AMENDMENT NO. 1 DECEMBER 1976
TO
IS : 3523-1974 SPECIFICATION FOR METAL TRAVELLERS FOR
RING SPINNING FRAME
(Second Revision)

FIG. 2 A TYPICAL STRETCH TESTING APPARATUS FOR TRAVELLERS

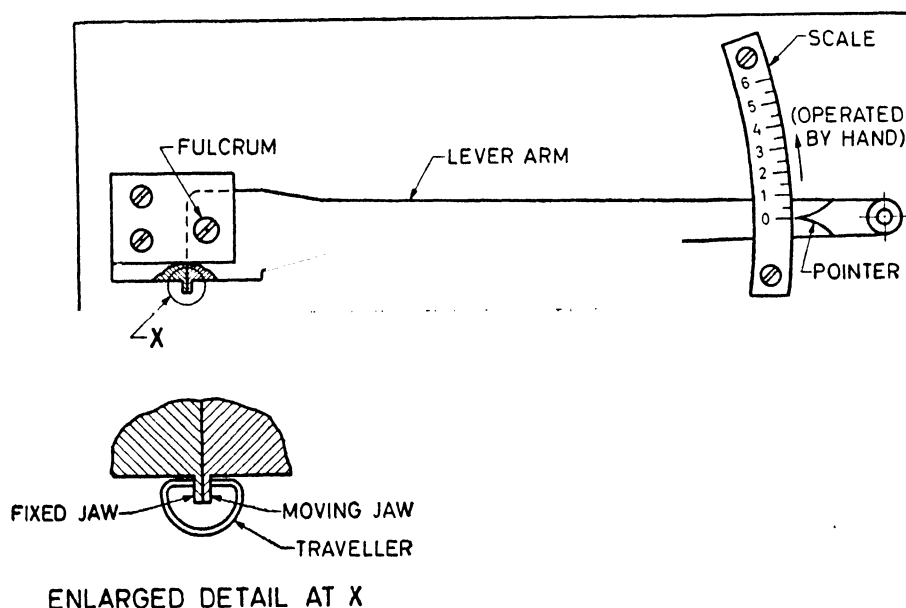
(Page 1, clause 3.4, line 3) — Add the following after ‘ 6 mm ’ :

(A typical stretch testing apparatus is illustrated in Fig. 2)
